**BEFORE THE PUBLIC UTILITIES COMMISSION OF THE STATE OF COLORADO**

**DOCKET NO. 21A-0141E**

IN THE MATTER OF THE APPLICATION OF PUBLIC SERVICE COMPANY OF COLORADO  
FOR APPROVAL OF ITS 2021 ELECTRIC RESOURCE PLAN AND CLEAN ENERGY PLAN

SUGGESTED REQUESTS TO PSCO FOR SUPPLEMENTAL DIRECT TESTIMONY

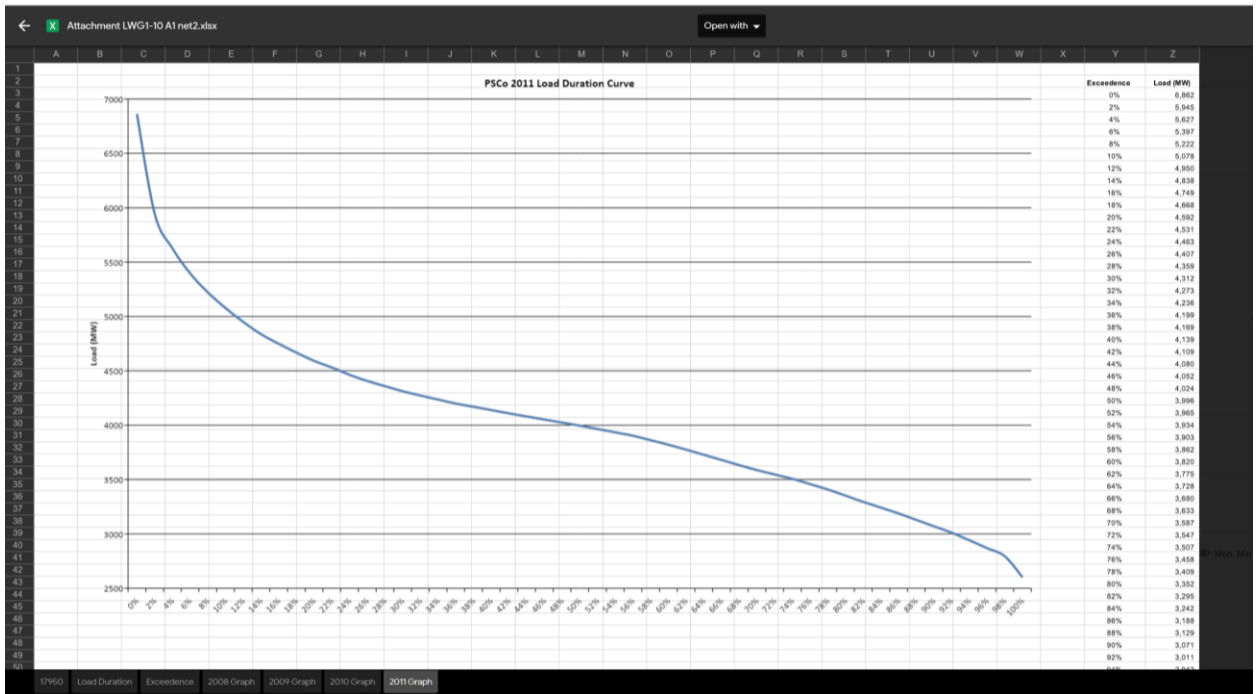
**Longer Explanation:** A typical load duration curve is shown below. While this curve is for 2011,<sup>6</sup> it is very likely that a 2020 curve obtained in discovery in this proceeding would have a substantially similar shape.

The load duration curve above shows clearly how there is a sharp peak in demand that is only experienced for a small percentage of the year.<sup>7</sup> For example, over 1000 MW of demand is only needed for about 2% of the year with most of that demand only experienced for one or two hours at a time (e.g. from 4-6 pm on a hot summer night). In that case 2-4 hours of storage can make a big difference.

Figure AKJ-D-1

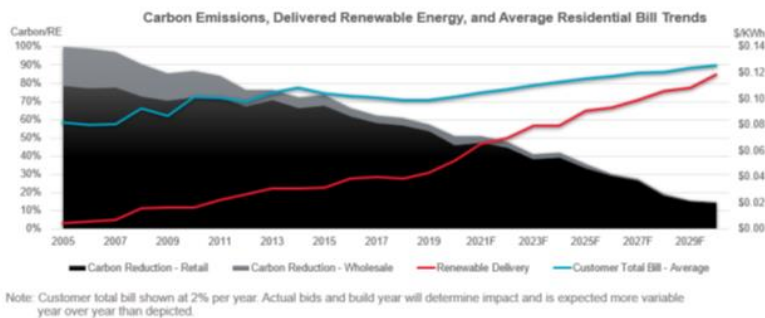
To protect Xcel’s Colorado customers, the Commission should request a breakdown of expected costs and an explanation of what happened to the “renewable dividend” and why Xcel’s bills are expected to increase at a rate of about 2% per year as shown in the blue line in AKJ-D-1 copied below.

**Request to PSCo for Supplemental Direct Testimony:** Many utilities that are shifting to higher levels of renewable generation are finding they are receiving a "renewable dividend." Please explain why Xcel is projecting steady cost increases and provide a breakdown of the source of those cost increases.

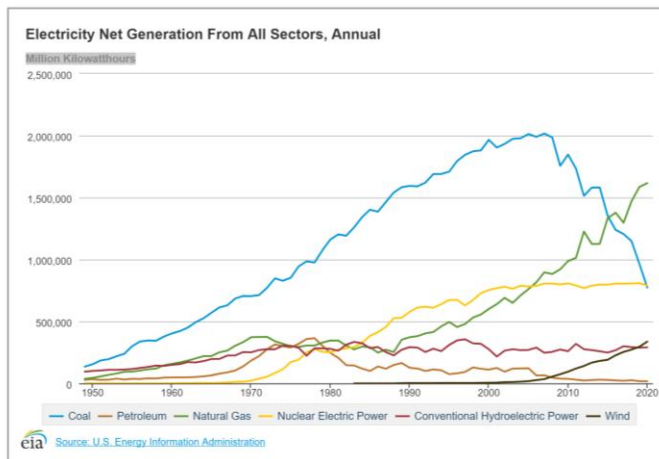
One of the many indicators of the structural decline of the US thermal coal industry is depicted in the graph below of coal's contribution to electricity production in the United States.<sup>16</sup>

The blue line in the graph above shows coal's contribution to US electric generation by year making the steep downward slope for coal generation very clear. While the future is always unknown, there is good reason to believe that the steep downward trend for thermal coal will continue through the 2020s with a very uncertain future by 2030—and perhaps even by 2025. As a result, Xcel's proposal to burn coal at the Pueblo Unit 3 coal plant until 2039 is very likely not a realistic one.
